Re: ACP-323780-25 Strategic Infrastructure Development - 10 year planning permission for Ballinlee Wind Farm consisting of 17 no. wind turbines, a permanent 110kV substation and ancillary development located in Ballincurra, Ballingayrou, Ballinlee North & South, Ballinrea, Ballyreesode, Camas North & South, Carrigeen, Knockuregare, Ballybane and other townlands in County Limerick.

**DIRECTOR GENERAL'S REPORT IN ACCORDANCE WITH THE  
REQUIREMENTS OF SECTION 37E (4) OF THE PLANNING AND  
DEVELOPMENT ACT 2000 (AS AMENDED) IN RELATION TO BALLINLEE  
WINDFARM**

**ACP REFERENCE: ACP-323780-25**

Figure 2. Discrepancy in location of proposed turbine T9.

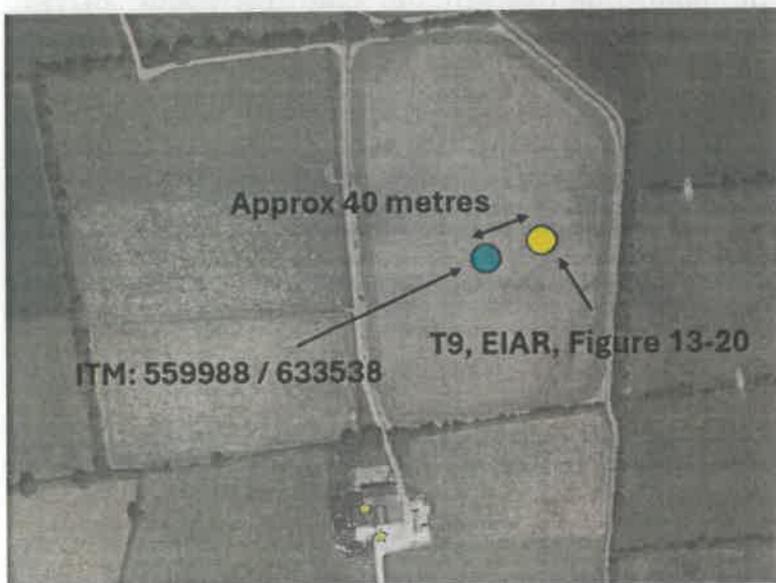
There is an error in the mapping of at least one of the proposed turbines in Chapter 13 of the EIAR. Figure 13-1 provides a mapped overview of the seventeen proposed turbine locations and the noise sensitive locations in the study area. It is difficult to determine the exact location of the proposed turbines in the figure due to the type of symbol used and the scale of the image. However, a more precise location for at least one of the proposed turbines, T9, is presented in Figure 13-20 (Figure 1 below), with its Irish Transverse Mercator (ITM) geographic coordinates provided in Table 13-24 (559988 / 633538).

T9 is plotted in Figure 13-20 approximately 40 metres northeast of the actual location of the ITM coordinates in Table 13-24 (Figure 2).

It appears that the noise sensitive receptors have been plotted correctly in the EIAR (e.g. NSLO56 in Figure 13-18 and NSLO61 in Figure 13-17, plotted from ITM coordinates in Appendix 13C). It is recommended that the consistency of the geographical projections used for all input and export files for the noise calculation model are reviewed to ensure the

- There is an error in the mapping of at least one of the proposed wind turbines, T9, and potentially the other proposed turbines in Figure 13-1. The geographic coordinates of the input and output files for the noise models should be reviewed as the error may compromise the accuracy of calculations at noise sensitive locations.

Figure 3. Discrepancy between the interpreted day-time noise limits for low background noise environments between LCCC (based on Figure 10 in ETSU-R-97) and the EIAR.

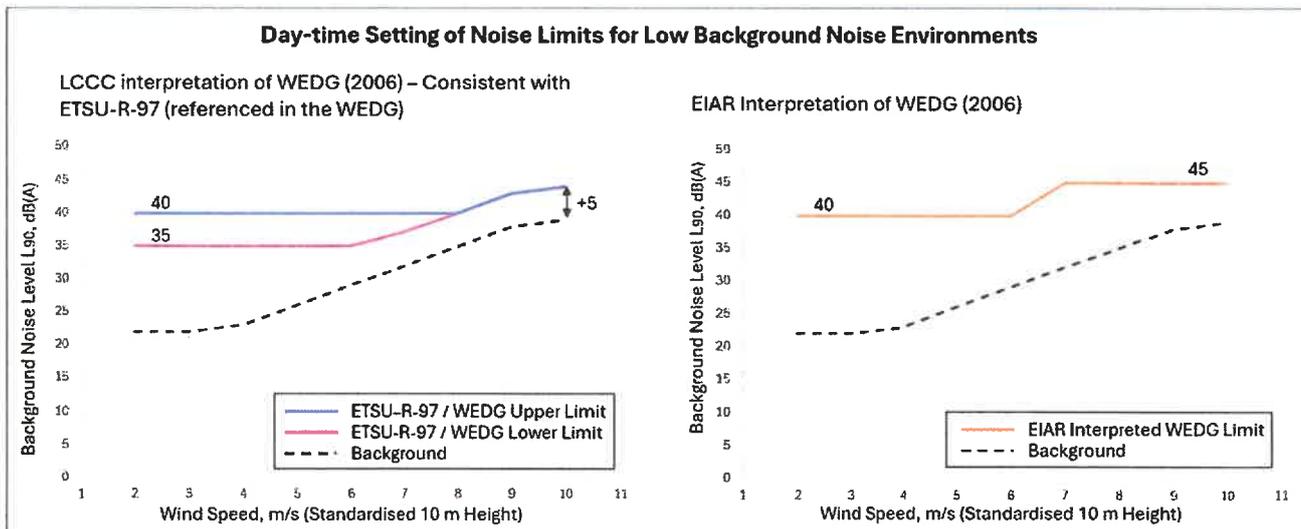
These three factors are not considered in the EIAR. The 40 dB(A) L90 limit is selected based on the EPA's *Guidance Note for Noise: Licence Applications, Surveys and Assessments in Relation to Scheduled Activities (NG4)* recommends a 45 dB(A) Leq limit for "areas of low background noise", and a 40 dB(A) L90 limit will be 5 dB below that. This approach is flawed though because the criteria for "areas of low background noise" in NG4 is that the background noise level shall be  $\leq 40$  dB(A) L90 which is 10 dB above the "low noise environment" criteria in the WEDG (a 10 dB reduction is an expected halving of perceived loudness for the average listener). There is a discrepancy between the two terms "areas of low background noise" in NG4 and "low noise environment" in the WEDG although they sound similar. There is a significant number of noise sensitive properties in the study area, many of which are downwind of turbines under predominantly southwesterly wind conditions.

The implication of a *low noise environment* is that for the wind speeds that the background noise is less than 30 dB(A) L90 the absolute noise limit should be between 35 and 40 dB(A) L90 but otherwise the noise limit should not be 5 dB above background noise (Figure 3, left). This is interpreted differently in the EIAR (Figure 3, right) suggesting that any time the background noise level is below 30 dB(A) L90 the turbine noise limit should be 40 dB(A) L90 - but could arguably be as low as 35 dB(A) L90) then - when the background noise level exceeds 30 dB(A) the turbine noise limit rises to 45dB (background noise level is 31 dB dB(A) L90 at 6 m/s). The EIAR approach allows wind turbine noise levels to be 18 dB above background noise at 2 m/s, reducing to 11 dB at 6 m/s, but then increasing again to 13 dB headroom at 7 m/s because the background noise has risen slightly above 30 dB(A). It is the opinion of LCCC that the EIAR approach to setting noise criteria is contrary to providing a reasonable degree of protection to residents.

As mentioned above, the approach to setting noise limits for *low noise environments* at day-time originates from the ETSU-R-97 guidance. The lower limit of 35 dB(A) or 40 dB(A) should be followed by a limit of 5 dB above background noise.

- The Wind Energy Development Guidelines (WEDG, 2006) reference ETSU-R-97 for the determination of noise limits. It is the planning authority's opinion that the day-time wind turbine noise limits should be derived being consistent with the ETSU-R-97 approach. The implication of a *low noise environment* is that for the wind speeds that the background noise is less than 30 dB(A) L90 the absolute noise limit should be between 35 and 40 dB(A) L90 but otherwise the noise limit should not be 5 dB above background noise (Figure 3 of main report above).

**Figure 2. Discrepancy in location of proposed turbine T9.**

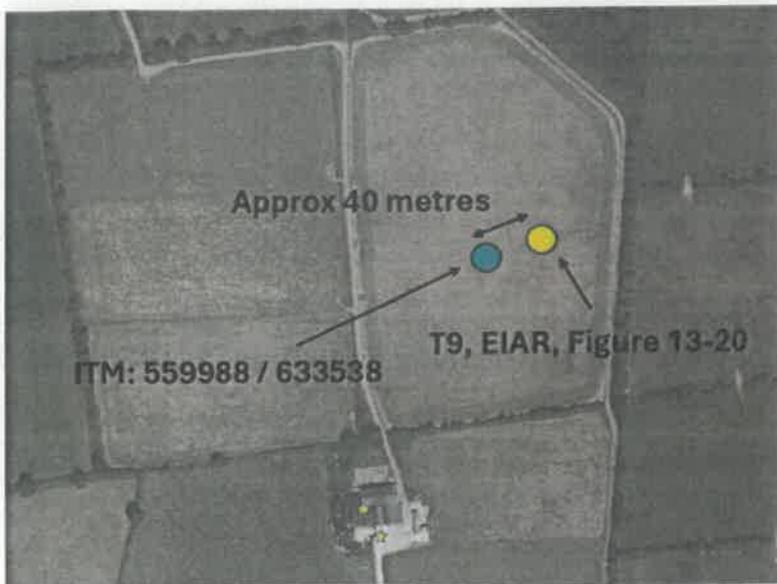
There is an error in the mapping of at least one of the proposed turbines in Chapter 13 of the EIAR. Figure 13-1 provides a mapped overview of the seventeen proposed turbine locations and the noise sensitive locations in the study area. It is difficult to determine the exact location of the proposed turbines in the figure due to the type of symbol used and the scale of the image. However, a more precise location for at least one of the proposed turbines, T9, is presented in Figure 13-20 (Figure 1 below), with its Irish Transverse Mercator (ITM) geographic coordinates provided in Table 13-24 (559988 / 633538).

T9 is plotted in Figure 13-20 approximately 40 metres northeast of the actual location of the ITM coordinates in Table 13-24 (Figure 2).

It appears that the noise sensitive receptors have been plotted correctly in the EIAR (e.g. NSLO56 in Figure 13-18 and NSLO61 in Figure 13-17, plotted from ITM coordinates in Appendix 13C). It is recommended that the consistency of the geographical projections used for all input and export files for the noise calculation model are reviewed to ensure the accuracy of predicted sound levels at noise sensitive locations and the noise contour plot in Appendix 13E.

- There is an error in the mapping of at least one of the proposed wind turbines, T9, and potentially the other proposed turbines in Figure 13-1. The geographic coordinates of the input and output files for the noise models should be reviewed as the error may compromise the accuracy of calculations at noise sensitive locations.
- Background noise levels at noise monitoring locations NML4 are probably higher than representative for typical low levels in the vicinity of dwellings in the southeast of the study area for higher wind speeds.
- There is a discrepancy between LCCC and the EIAR interpretations for setting of noise limits for day- and night-time.
- The proposed noise limits will potentially allow turbine noise levels to be significantly above background noise at night-time and day-time at moderate wind speeds (up to 18 dB and 14 dB, respectively, downwind at wind speeds of 6 m/s).

**Figure 3. Discrepancy between the interpreted day-time noise limits for low background noise environments between LCCC (based on Figure 10 in ETSU-R-97) and the EIAR.**

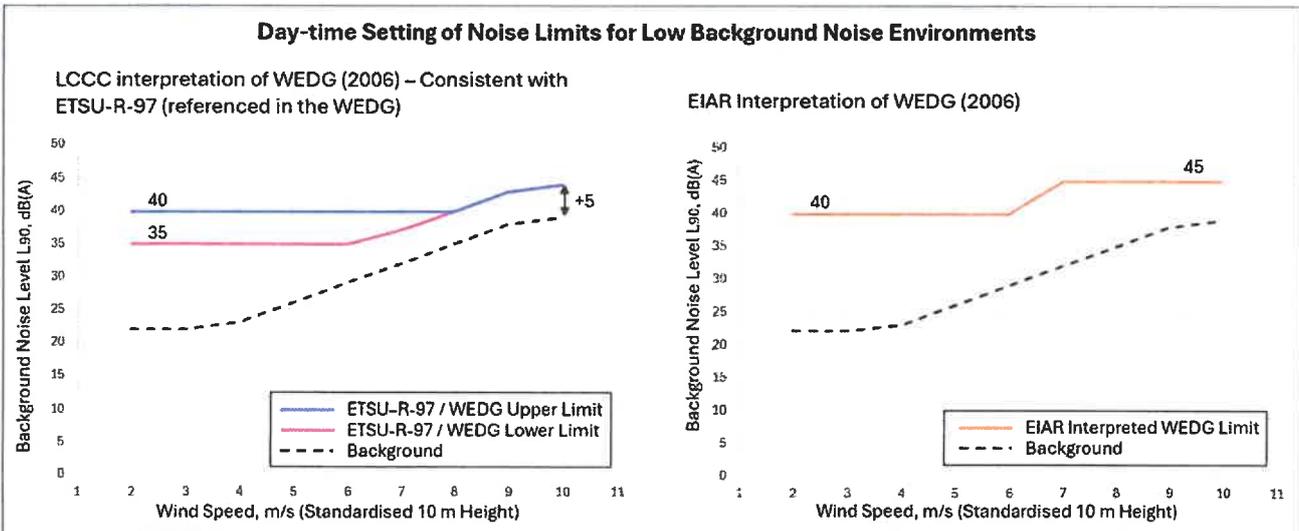
These three factors are not considered in the EIAR. The 40 dB(A) L90 limit is selected based on the EPA's *Guidance Note for Noise: Licence Applications, Surveys and Assessments in Relation to Scheduled Activities (NG4)* recommends a 45 dB(A) Leq limit for “*areas of low background noise*”, and a 40 dB(A) L90 limit will be 5 dB below that. This approach is flawed though because the criteria for “*areas of low background noise*” in NG4 is that the background noise level shall be  $\leq 40$  dB(A) L90 which is 10 dB above the “*low noise environment*” criteria in the WEDG (a 10 dB reduction is an expected halving of perceived loudness for the average listener). There is a discrepancy between the two terms “*areas of low background noise*” in NG4 and “*low noise environment*” in the WEDG although they sound similar. There is a significant number of noise sensitive properties in the study area, many of which are downwind of turbines under predominantly southwesterly wind conditions.

The implication of a *low noise environment* is that for the wind speeds that the background noise is less than 30 dB(A) L90 the absolute noise limit should be between 35 and 40 dB(A) L90 but otherwise the noise limit should not be 5 dB above background noise (Figure 3, left). This is interpreted differently in the EIAR (Figure 3, right) suggesting that any time the background noise level is below 30 dB(A) L90 the turbine noise limit should be 40 dB(A) L90 - but could arguably be as low as 35 dB(A) L90) then - when the background noise level exceeds 30 dB(A) the turbine noise limit rises to 45dB (background noise level is 31 dB dB(A) L90 at 6 m/s). The EIAR approach allows wind turbine noise levels to be 18 dB above background noise at 2 m/s, reducing to 11 dB at 6 m/s, but then increasing again to 13 dB headroom at 7 m/s because the background noise has risen slightly above 30 dB(A). It is the opinion of LCCC that the EIAR approach to setting noise criteria is contrary to providing a reasonable degree of protection to residents.

As mentioned above, the approach to setting noise limits for *low noise environments* at day-time originates from the ETSU-R-97 guidance. The lower limit of 35 dB(A) or 40 dB(A) should be followed by a limit of 5 dB above background noise.

- The Wind Energy Development Guidelines (WEDG, 2006) reference ETSU-R-97 for the determination of noise limits. It is the planning authority's opinion that the day-time wind turbine noise limits should be derived being consistent with the ETSU-R-97 approach. The implication of a *low noise environment* is that for the wind speeds that the background noise is less than 30 dB(A) L90 the absolute noise limit should be between 35 and 40 dB(A) L90 but otherwise the noise limit should not be 5 dB above background noise (Figure 3 of main report above).

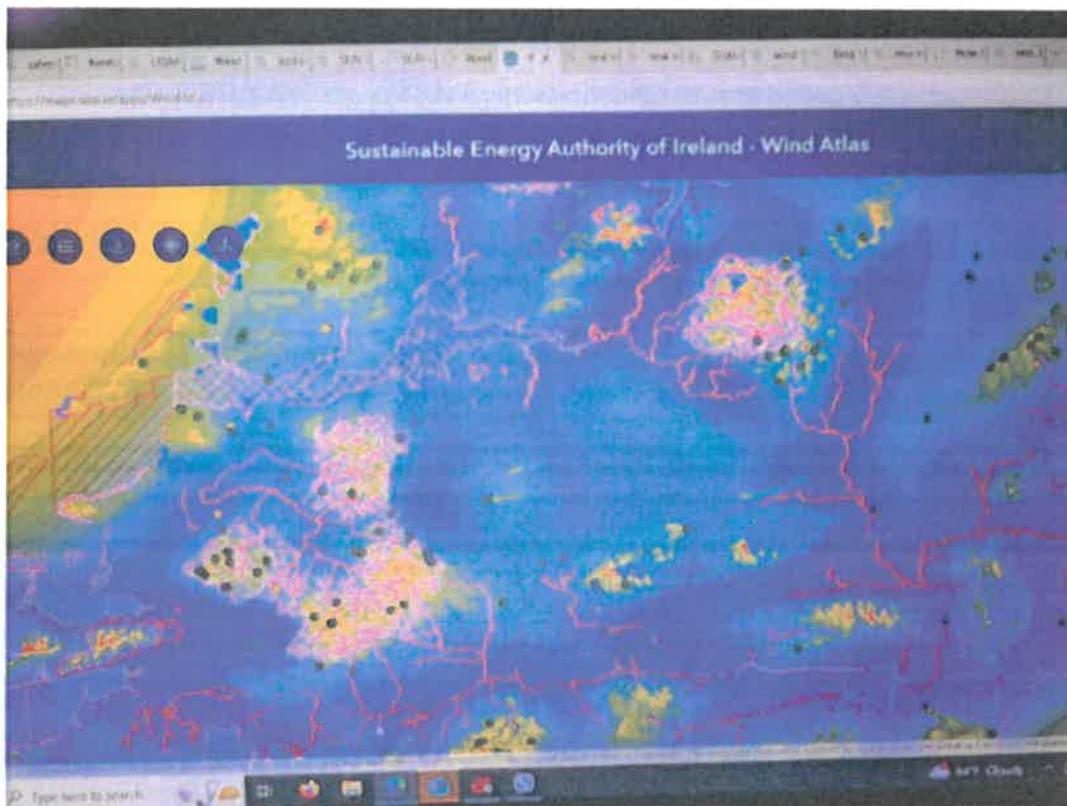
- In an effort to capture SID treatment by exceeding 50 MegaWatts of capacity the turbines are too close together and will "wake" each other. That is to say the wind will be disturbed on striking the first turbine and will be turbulent when striking the following turbines behind and beside. This array wake effect as more fully illustrated

elsewhere in a submission on waking will further reduce the capacity factor at Ballinlee by as much as 20% to 40% with a potential reduction in capacity factor to between 10.868% and 8.15%

South Cluster T6-T17

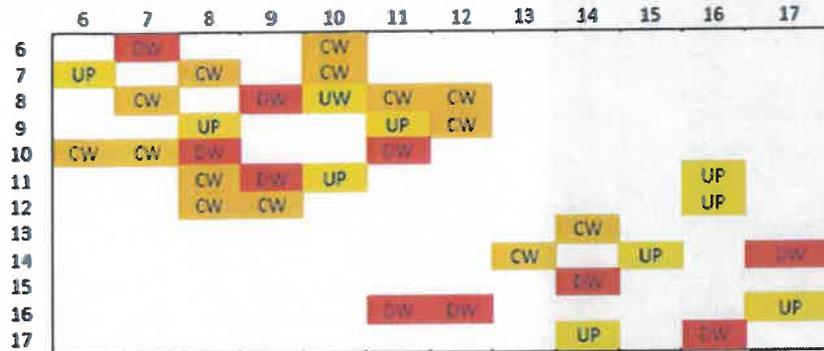
Colours indicate a breach of the guidelines where a turbine in Red is downwind of a corresponding front turbine indicated in Yellow.  
Brown indicates a pair of turbines in crosswind breach

Similar exercises can be performed for South and West wind and the results are broadly similar. These breaches are not minor, they are major in terms of how closely these turbines are packed together. The quantum of the breach is tabulated below where the actual distances between the non compliant turbines are expressed as a percentage of the 2006 guidelines. Also the distances as a percentage of the industry guidelines of 3.5 to 5 diameters crosswind and 6 to 10 diameters downwind are tabulated. The conclusion is that these arrays are manifestly in breach of the national guidelines as well as the wind industry itself.
